RESPONSE TO QUESTIONS ON BROWNS FERRY RECONSTITUTED FUEL

Reference: Letter from S. Black to O. D. Kingsley, Jr., dated September 13, 1989, "Revised Reload Technical Specifications (TAC 00450) (TS 254) Browns Ferry Nuclear Plant Unit 2"

Response to NRC Region II Questions
Browns Ferry Reconstituted Fuel

Figure 4: Symmetric R2/3 Bundle Power

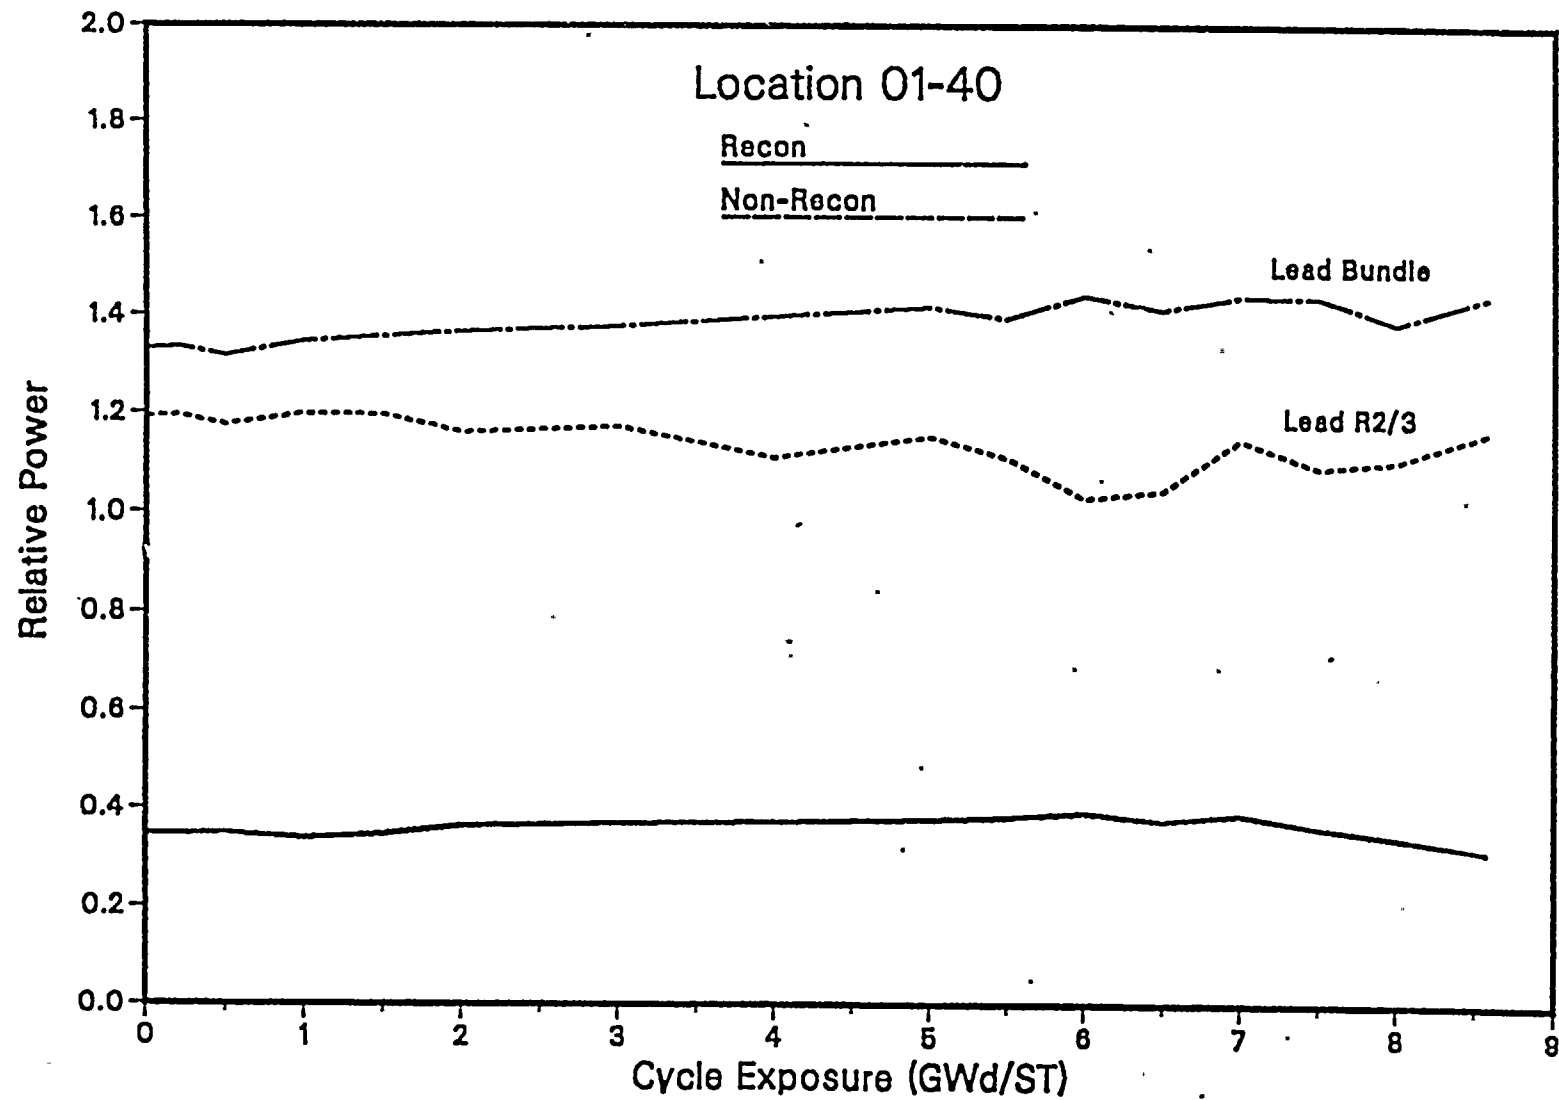
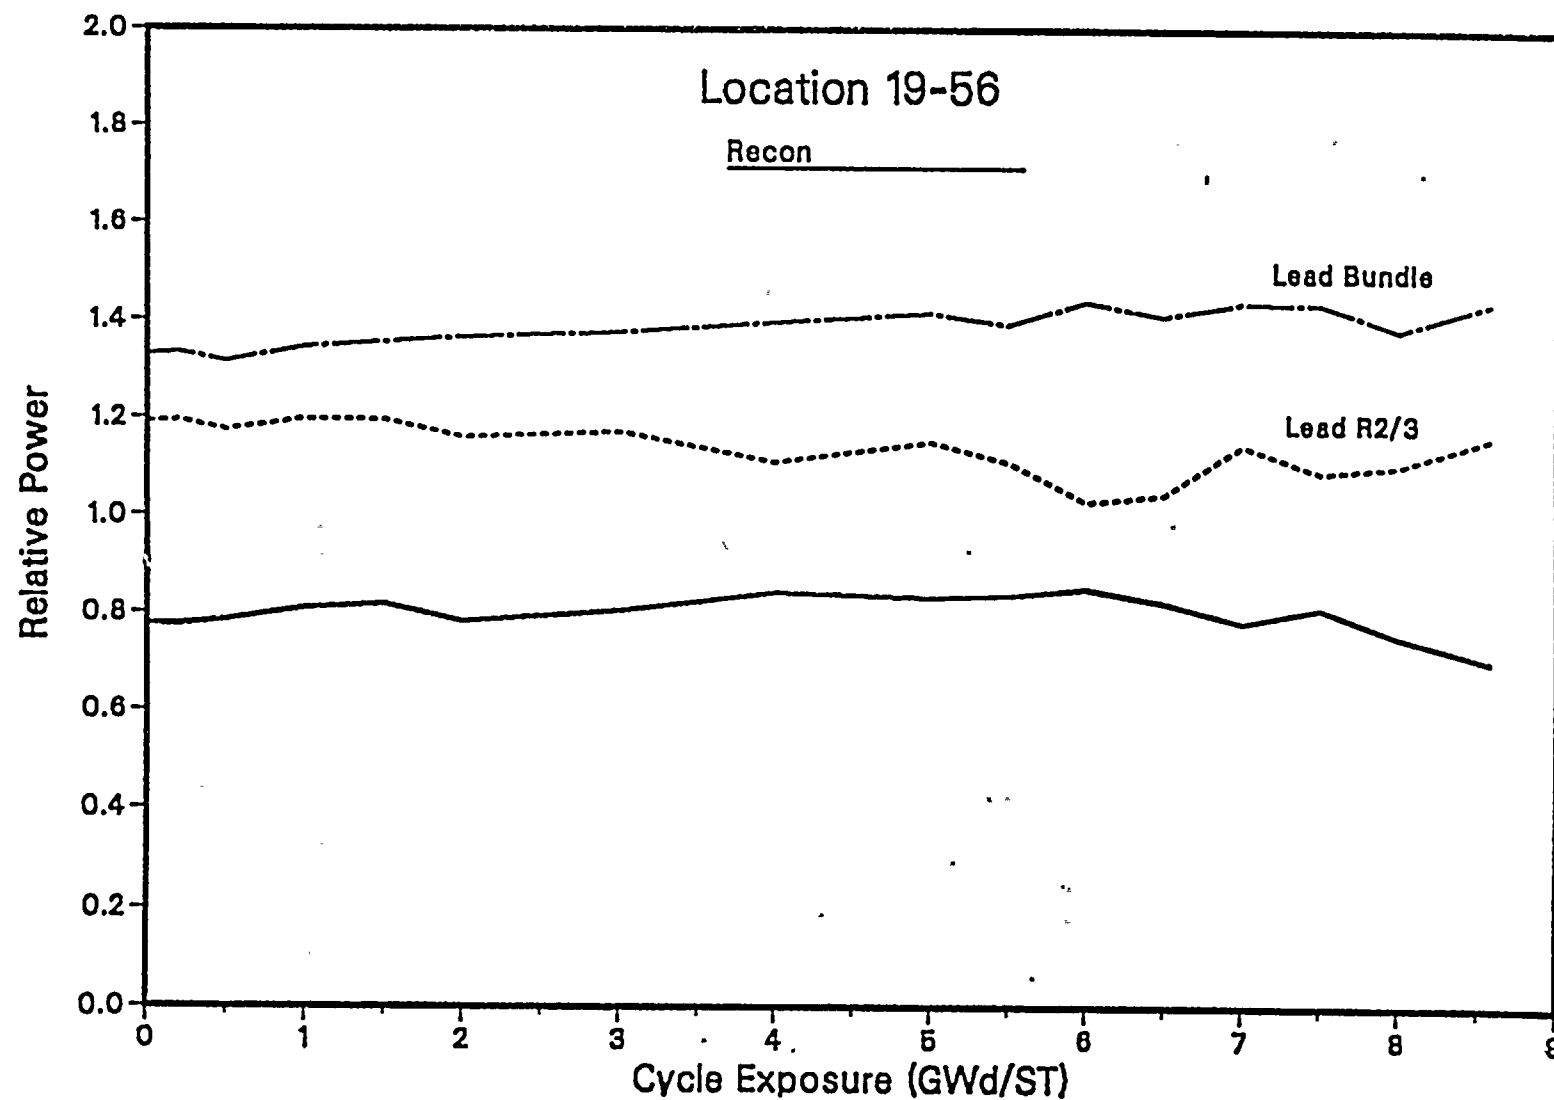
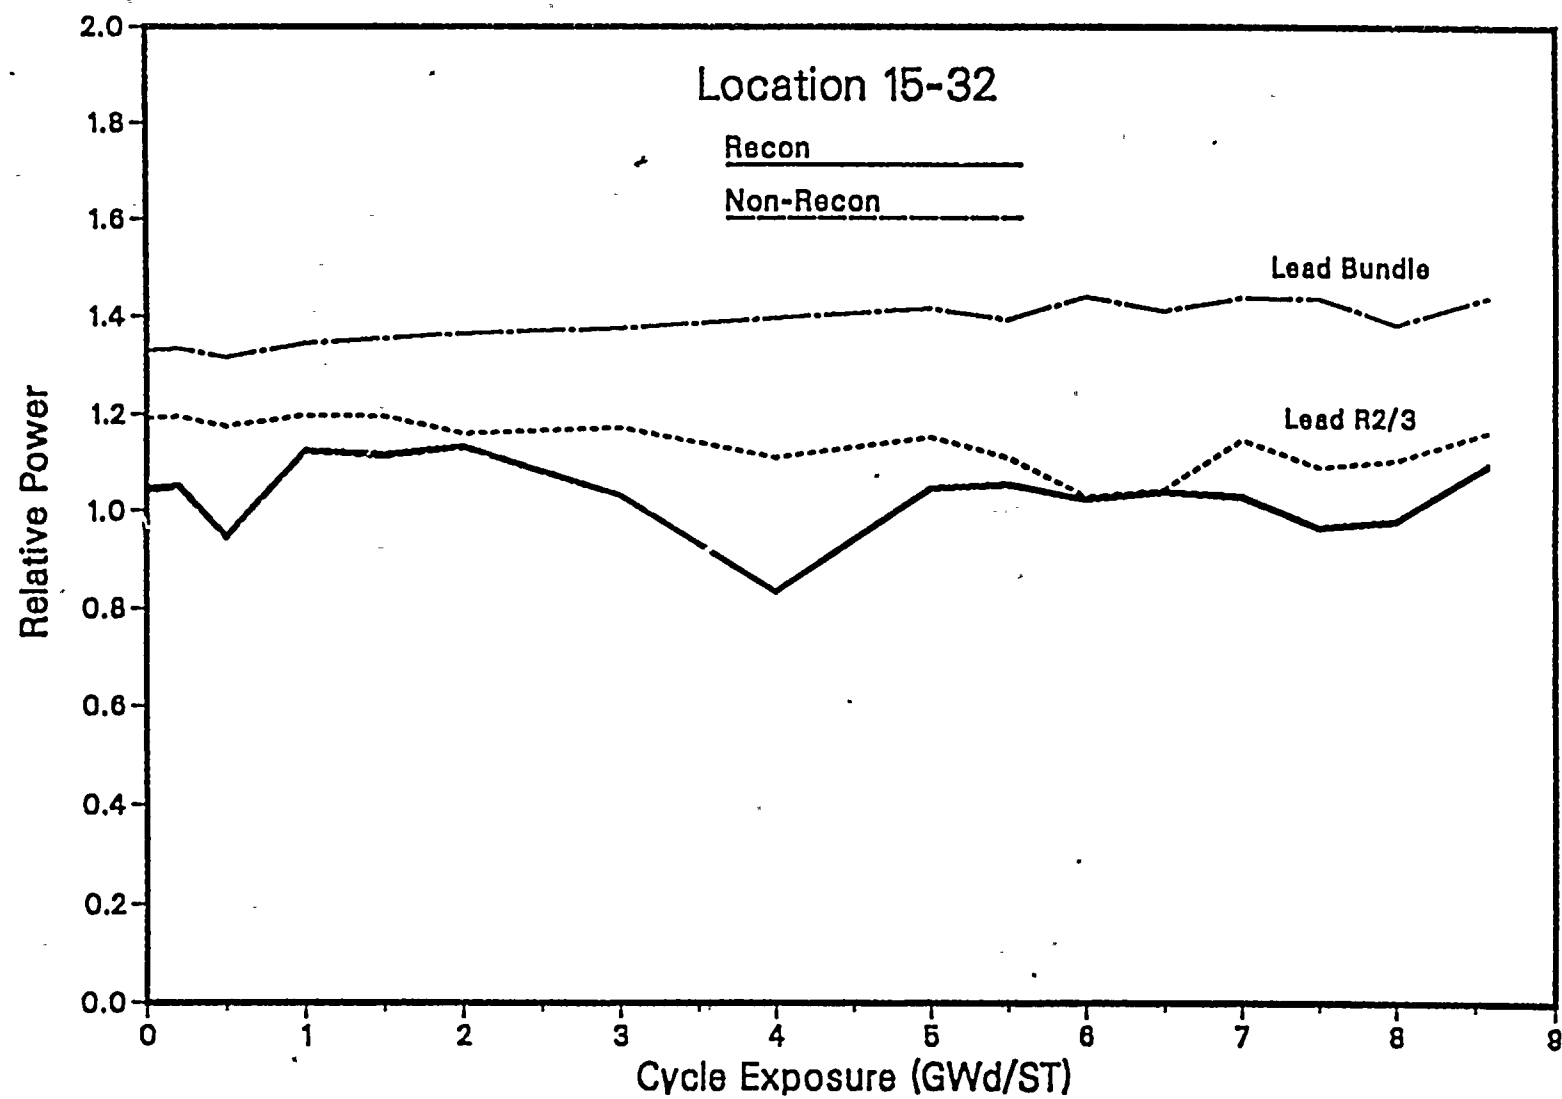
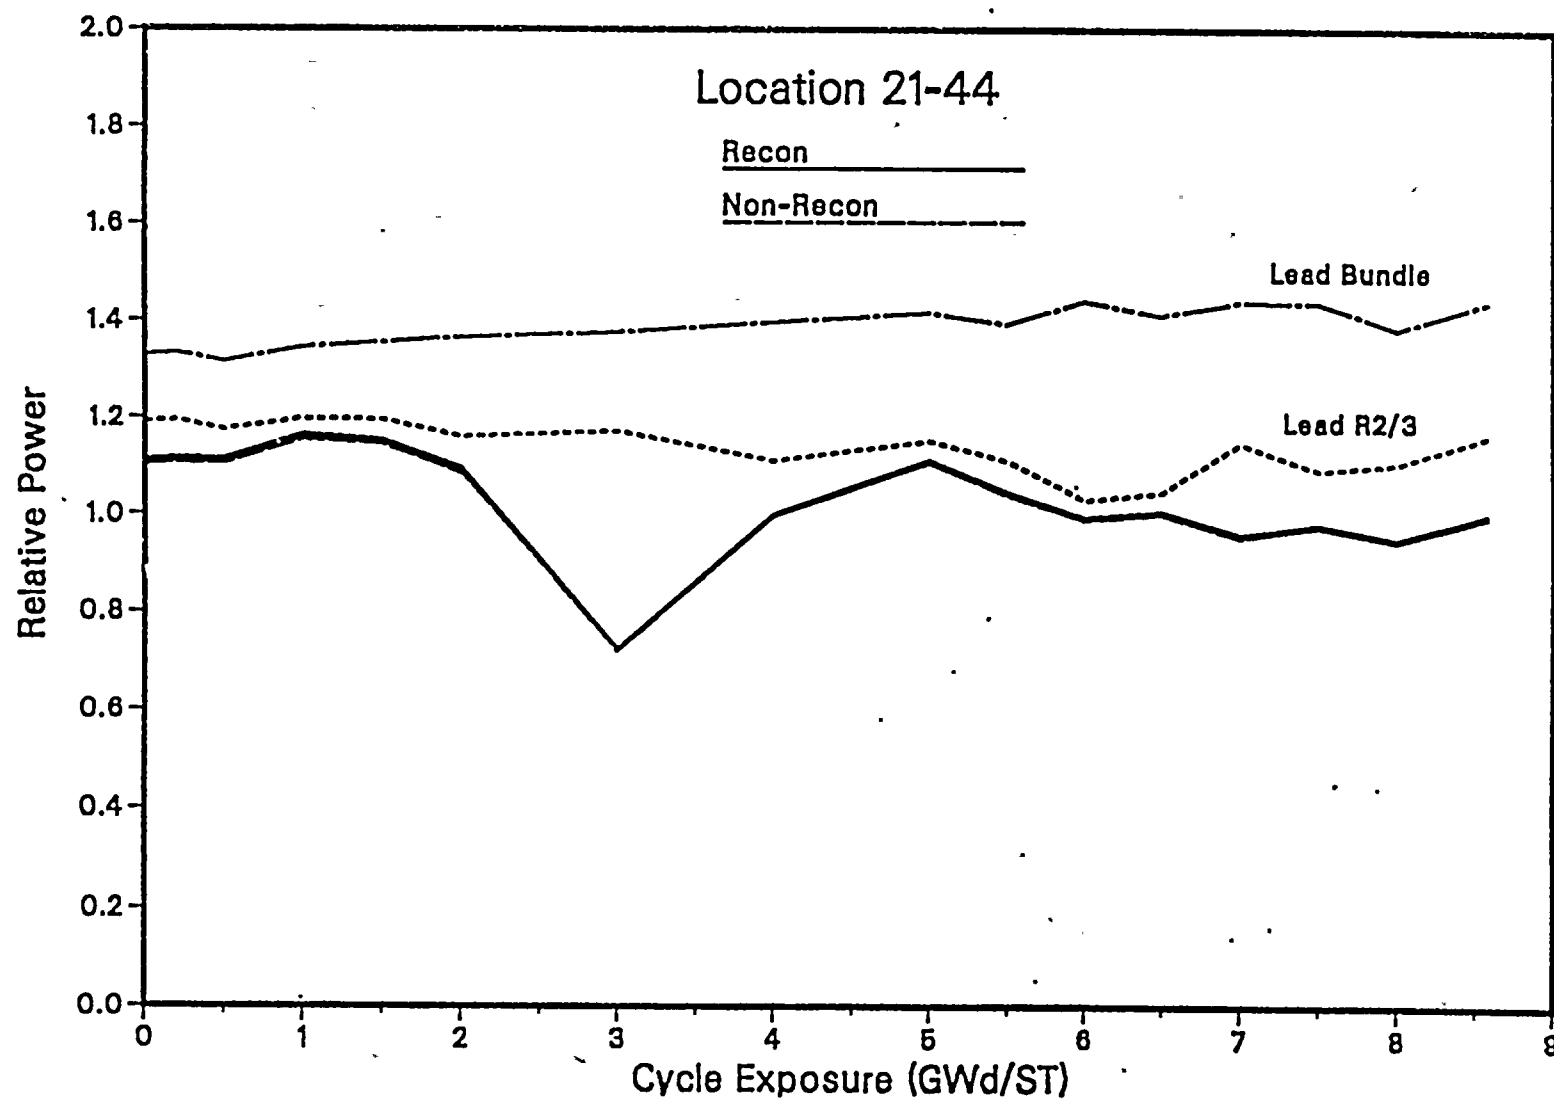
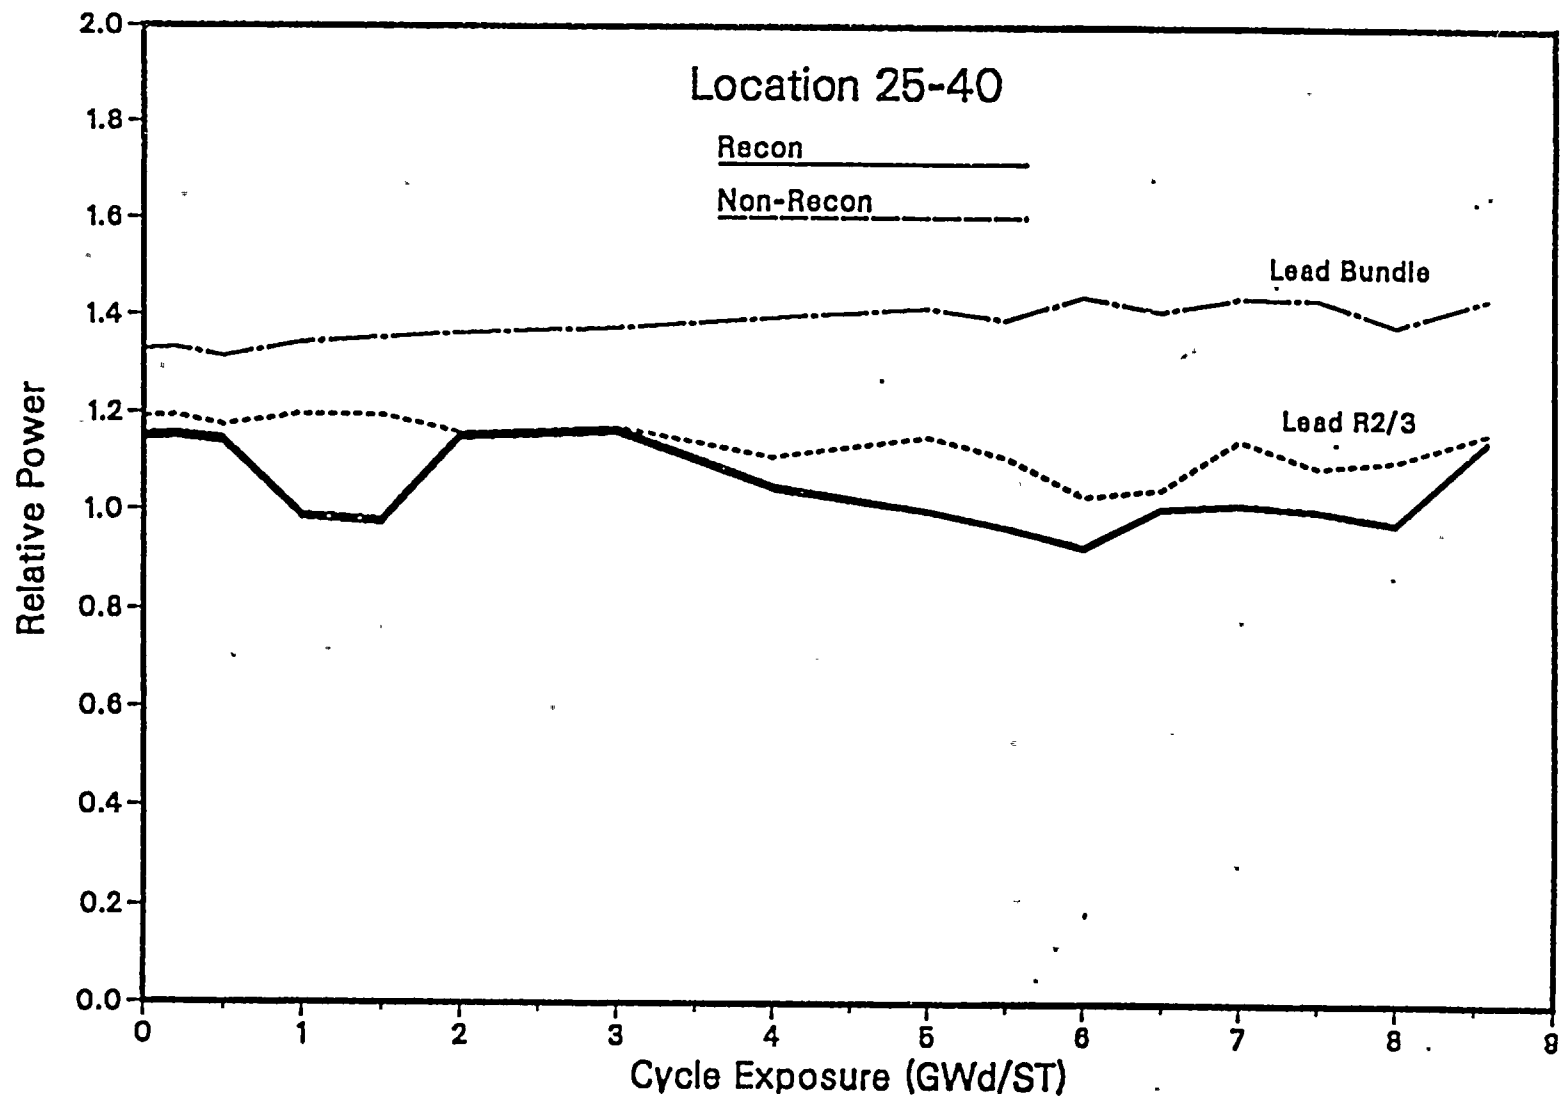
What is the typical bundle power experienced by reconstituted fuel during the cycle? Please provide results for maximum, average, and minimum power bundles.

Figure 4 provides the relative power for individual Reload 2 and 3 bundles during the cycle. Each figure contains results for the four bundles in 1/4 core symmetric locations. The locations were chosen to cover a wide range of bundle power and, when possible, to allow comparison of reconstituted and non-reconstituted bundles. The results show that there is essentially no difference in power among the symmetric locations and between reconstituted and non-reconstituted bundles. This result is expected since the differences in neutronics characteristics following reconstitution were generally small and the effects were modeled in the analyses to determine the final loading pattern.
